CITY OF BUELLTON

PLANNING COMMISSION AGENDA

To: The Honorable Chair and Commission Members
From: Andrea Keefer, Assistant Planner
Date: January 19, 2017
Subject: Preliminary Review of “The Network” Project
16-FDP-07

To: The Honorable Chair and Commission Members
From: Marc Bierdzinski, City Manager/Planning Director
Date: January 19, 2017
Subject: Preliminary Review – The Buellton Hub, 16-FDP-06

A3.1
 EXTERIOR ELEVATIONS

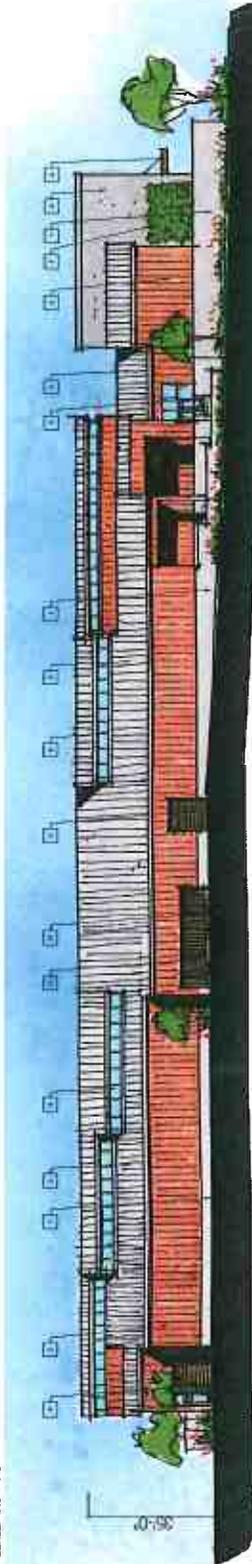
1. Style is being reviewed as Contemporary Ranch. Besides the lack of details, the design style and color schemes appear complete and addresses design standards.
2. Please provide details that show how the design is carried out. Typical details include roof eaves, gutters and downspouts, window trims, awnings, and any other character/project specific details.
3. Show light fixture locations on exterior elevations.

PRELIMINARY LANDSCAPE PLAN

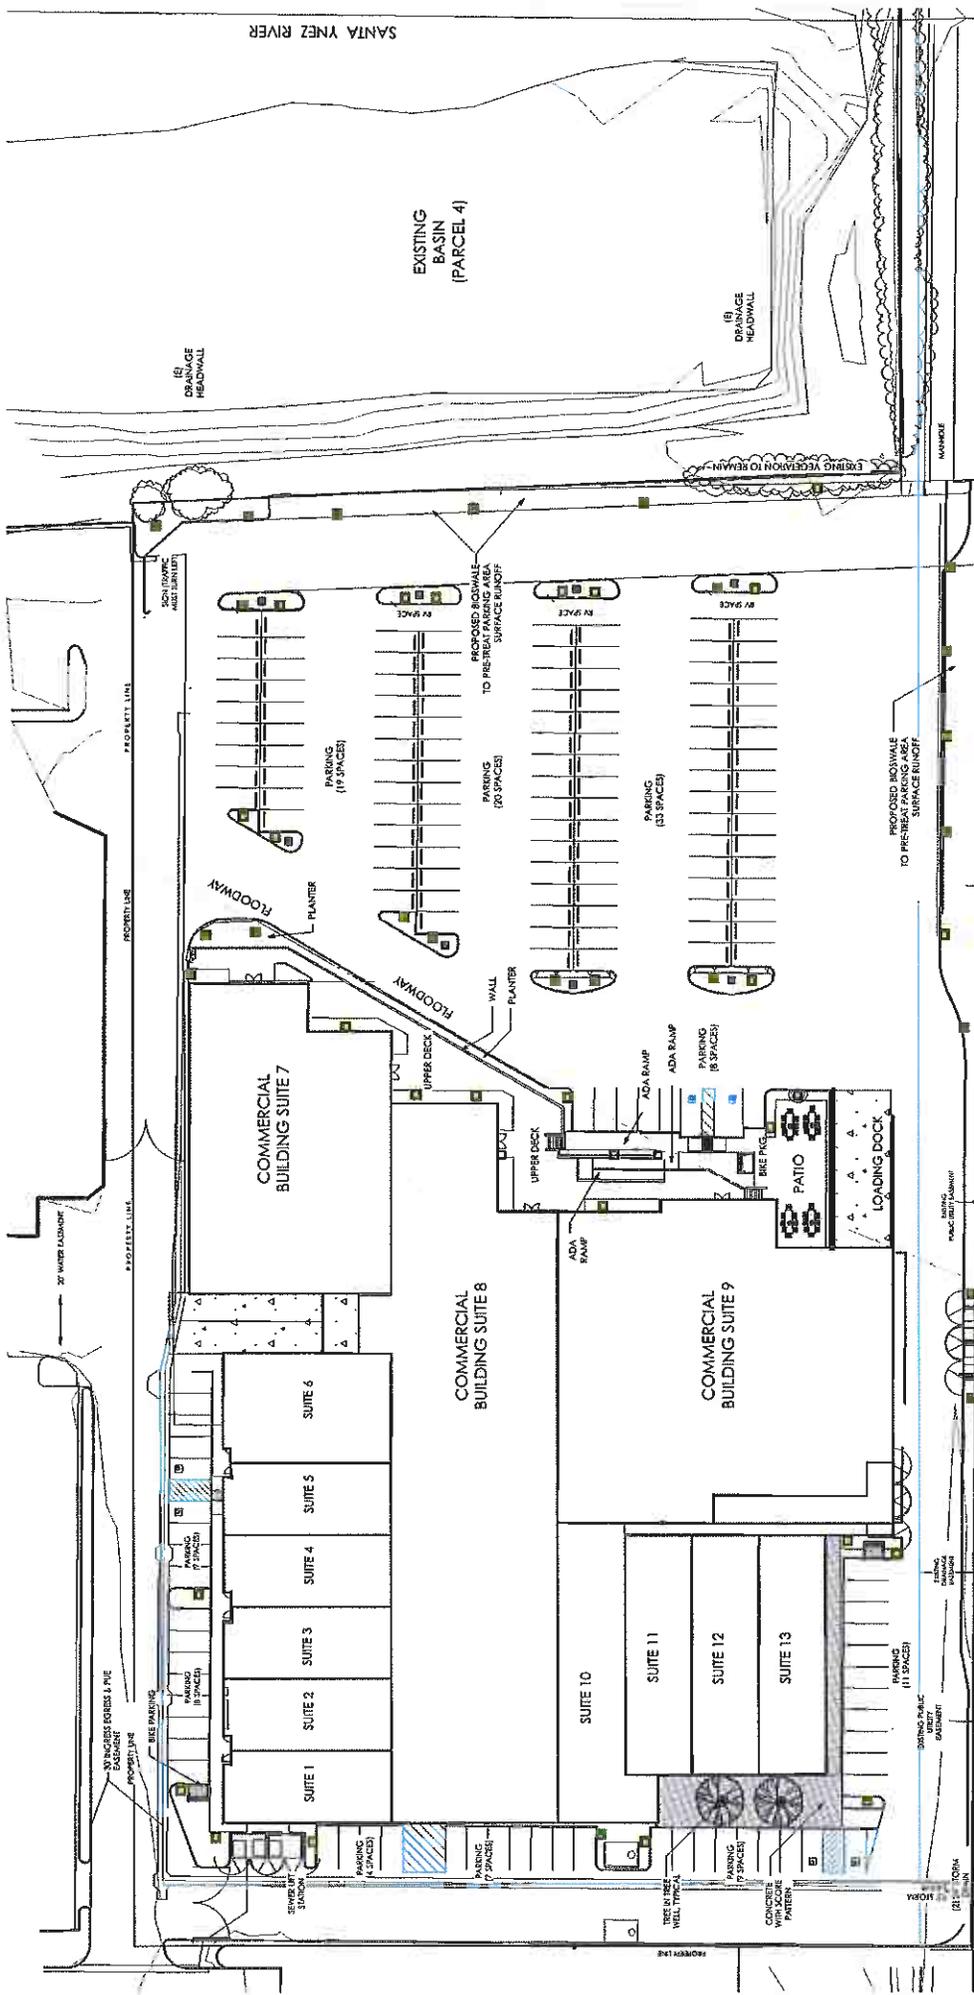
- f. More detail is needed on proposed access gates.
3. Landscape and Lighting Plans:
- a. The landscape plan needs to specify tree species in accordance with the City's Approved Tree Planting List. If a tree is proposed, but not on the approved tree list, provide an explanation on the tree's appropriateness for the area.

- b. Landscape Plans must include the Model Water Efficiency Landscape Ordinance statement to ensure compliance.
 - c. A Photometric lighting plan shall be provided, and shall include all exterior lighting for the project.

- f. Clear labels identifying the location of all existing trees with trunk diameters over 3", showing type, trunk and canopy diameter; tabulate and indicate the status of each tree identified (e.g. to be removed, saved, relocated) and applicable replacement requirements to be incorporated into landscape plans.
